CREST RIDGE
PRELIMINARY OVERALL AREA DEVELOPMENT PLAN
File #439

RE: Revised Crest Ridge Subdivision POADP #439

RE: Crest Ridge Subdivision POADP #439

Reference: Crestridge Subdivision POADP File #439

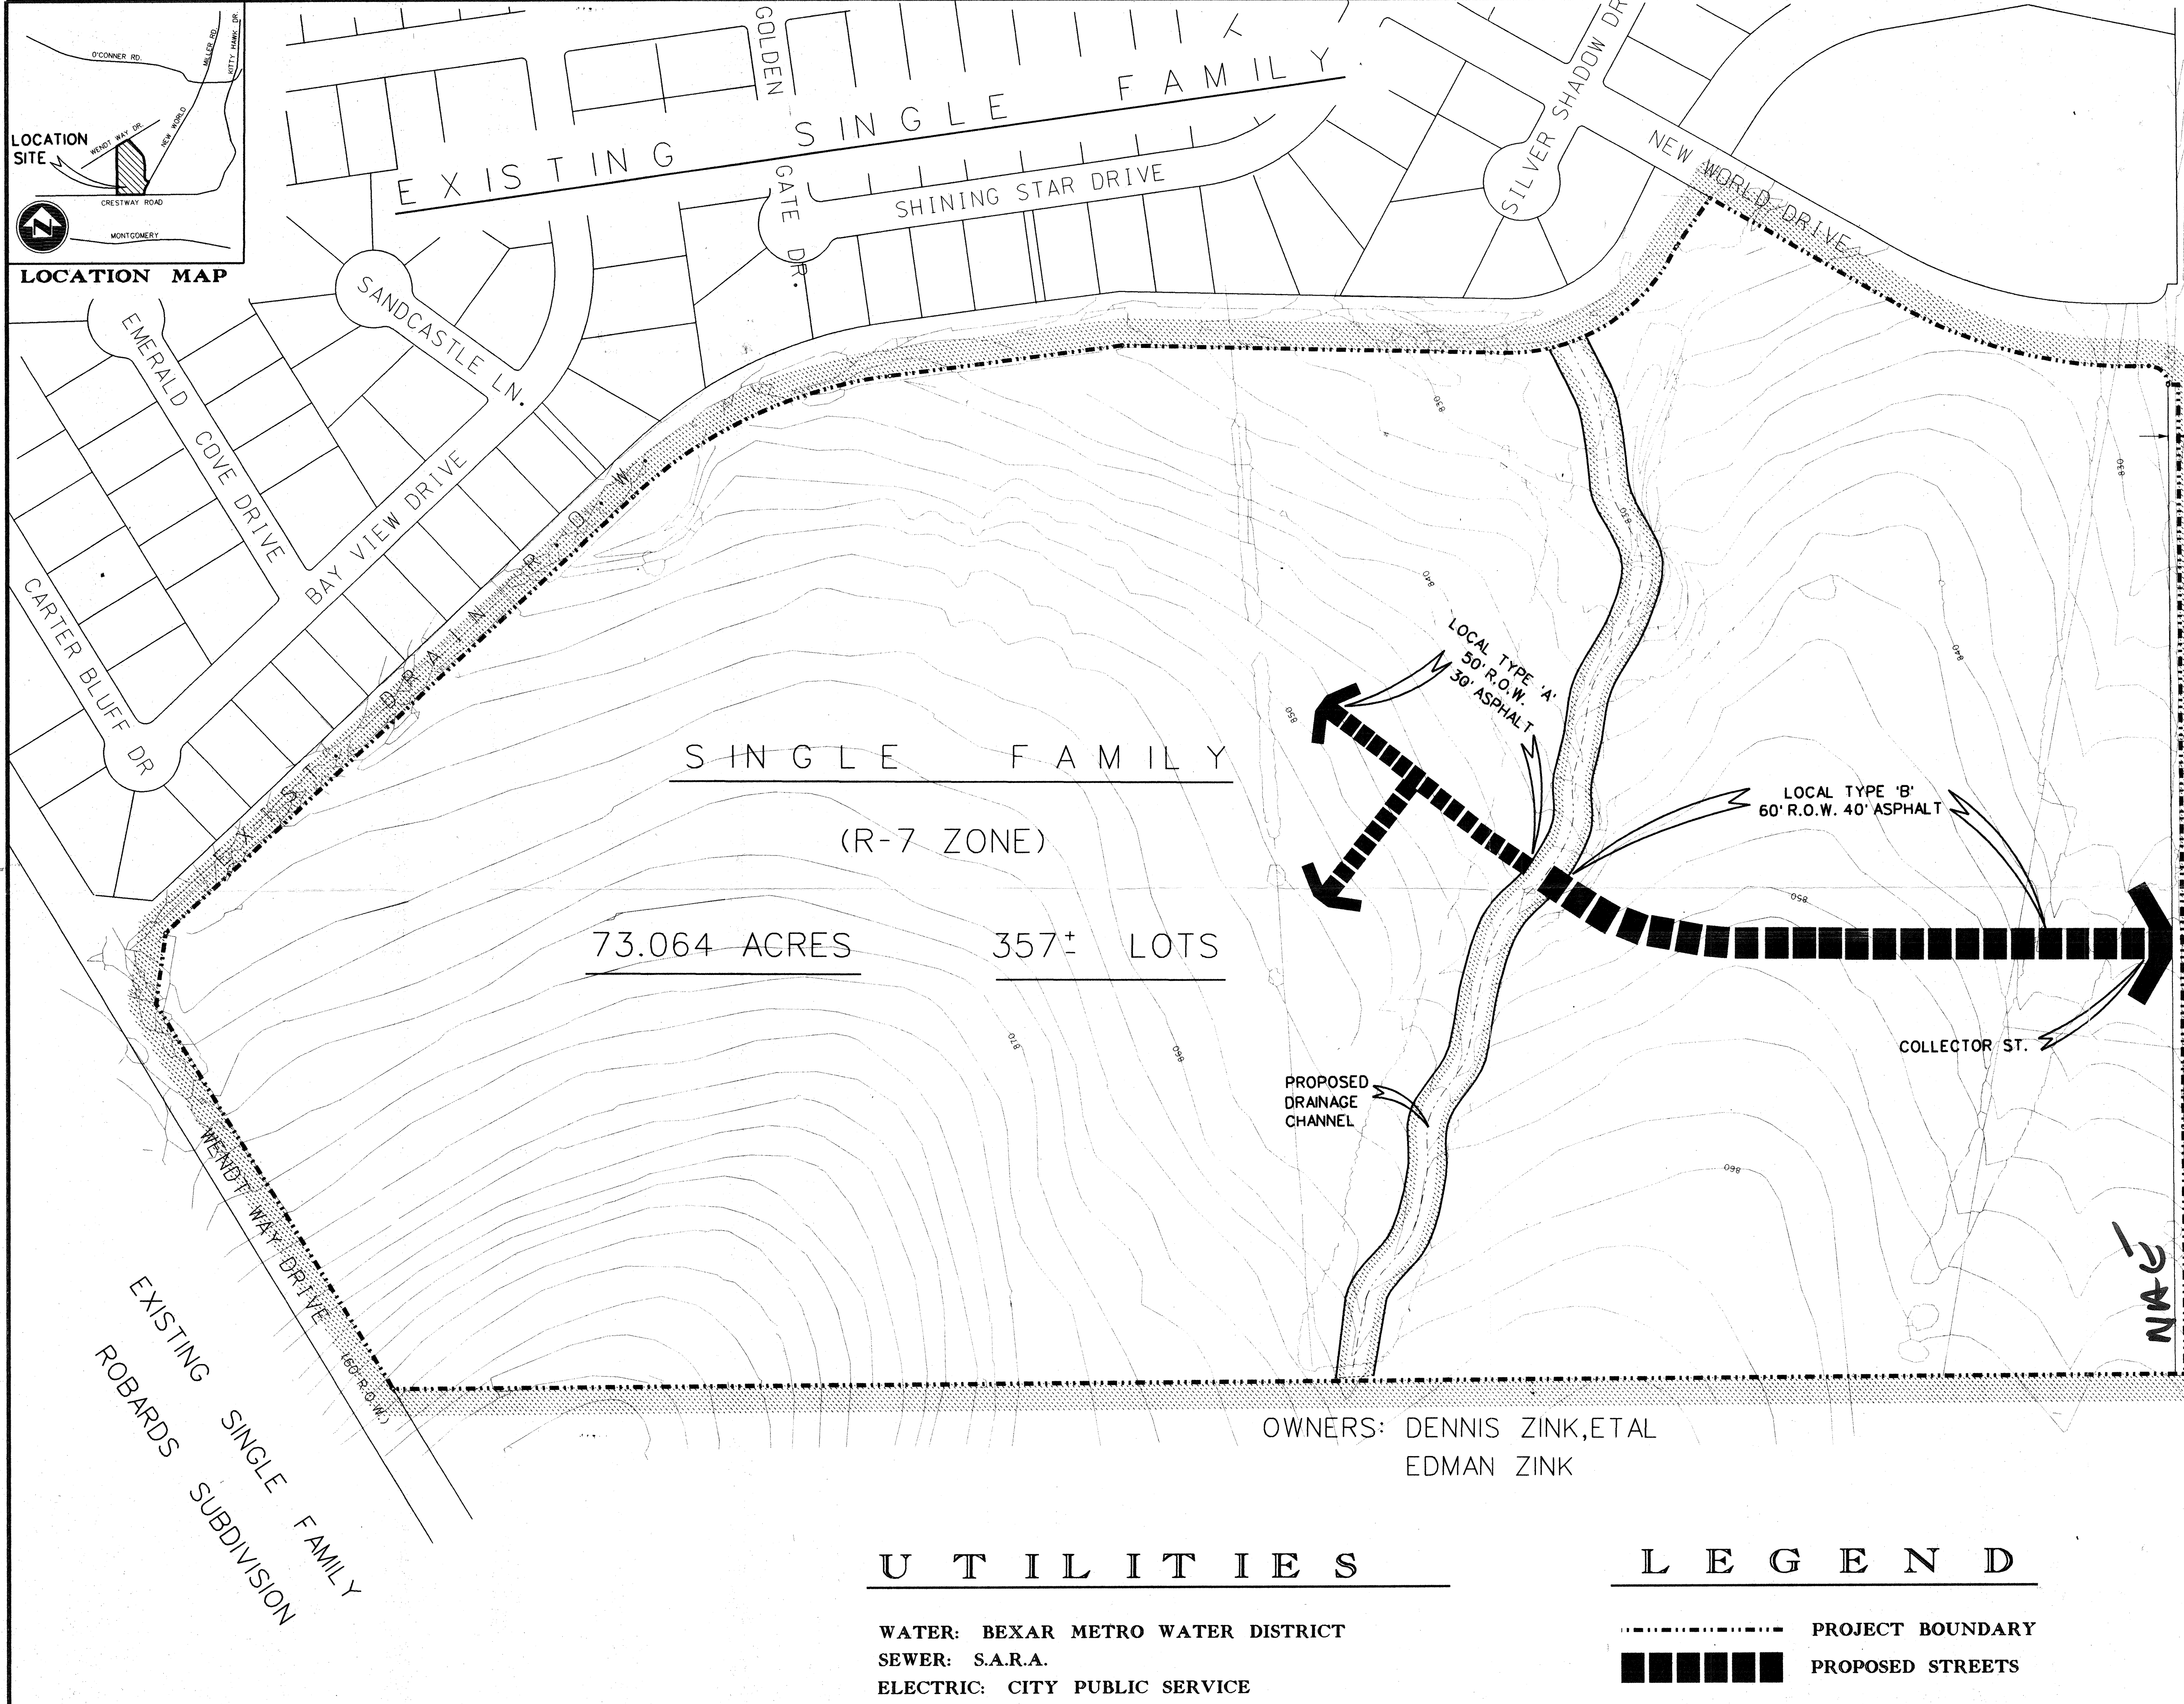
1. As shown on your plan, the entrance street will be platted, dedicated, and constructed as a sixty (60) foot collector with forty (40) feet of pavement.
2. Also as shown on your plan, you will be required to dedicate thirteen (13) feet adjacent to Crestway Road at the time of plat submittal.
3. Additionally, you will be required to provide a non-access easement along the rear and sides of all single-family residential lots adjacent to Crestway Road.

1. The Traffic Planning Engineer has indicated that based on the "Hierarchy of Streets", a collector is required as your entrance street from Crestway north. This collector needs to be completely delineated on your plan.
2. The Traffic Planning Engineer has also indicated that based on the number of lots you are projecting, two (2) access points rather than a single entry would be more appropriate.

As indicated on your plan, dedication will be required along Crestway. This dedication needs to bring Crestway up to an 86 foot arterial (43 feet from centerline).

Enclosed is a revised, Preliminary Overall Area Development Plan, for Crestridge Subdivision, for your review. The plan reflects, a 60 foot wide street right-of-way, starting at Crestway and terminating at a proposed drain channel. As indicated the Single Family Project, will consist of 73.064 Acres of Land and will contain approximately 357 Lots, with a density of 5.0 dwelling units per acre.
